Certificate of Appropriateness 2003 Van Hise Avenue

June 28, 2021

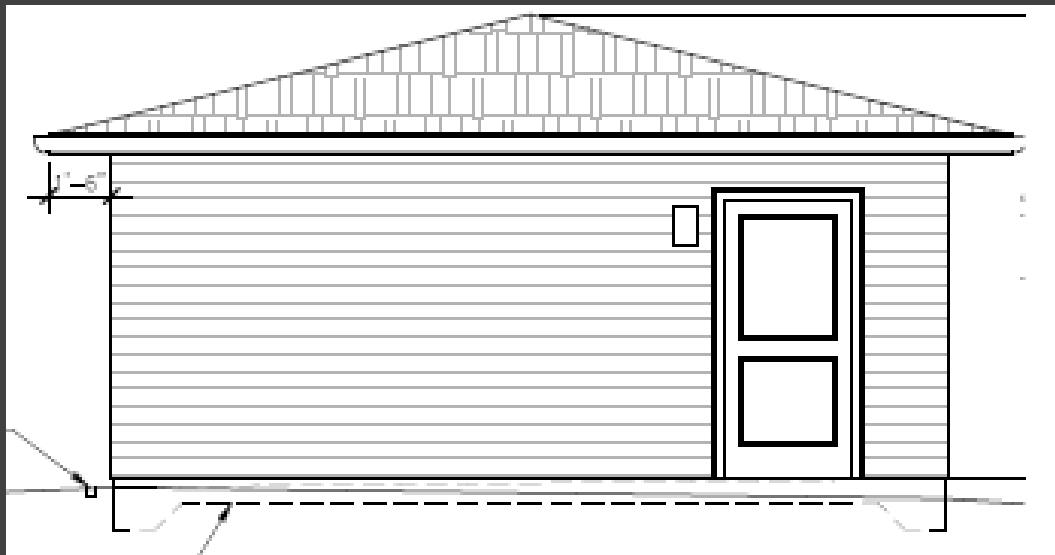
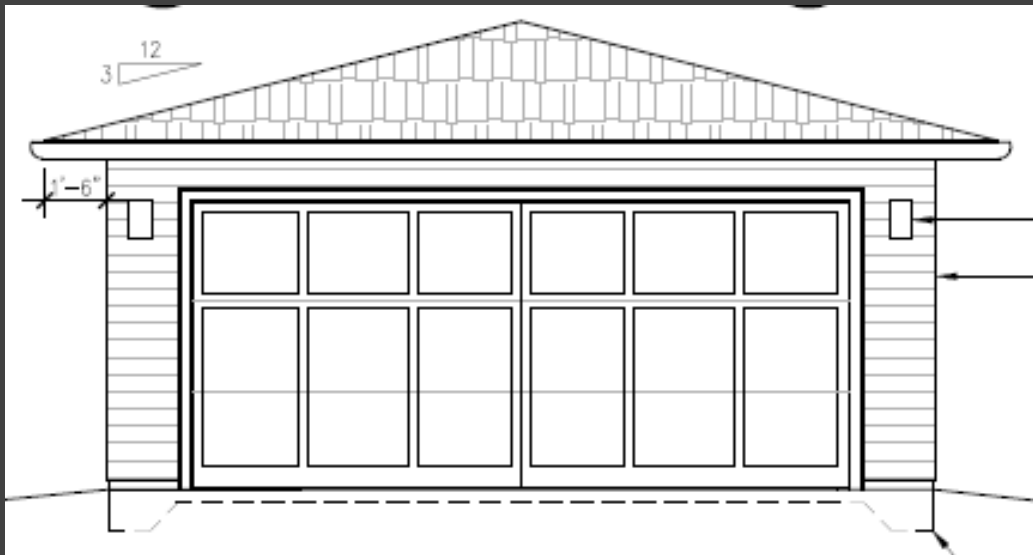
Staff believes that the standards for granting a Certificate of Appropriateness could be met and recommends that the Landmarks Commission approve the project with the following condition:

1. No faux hardware on the garage's vehicle door
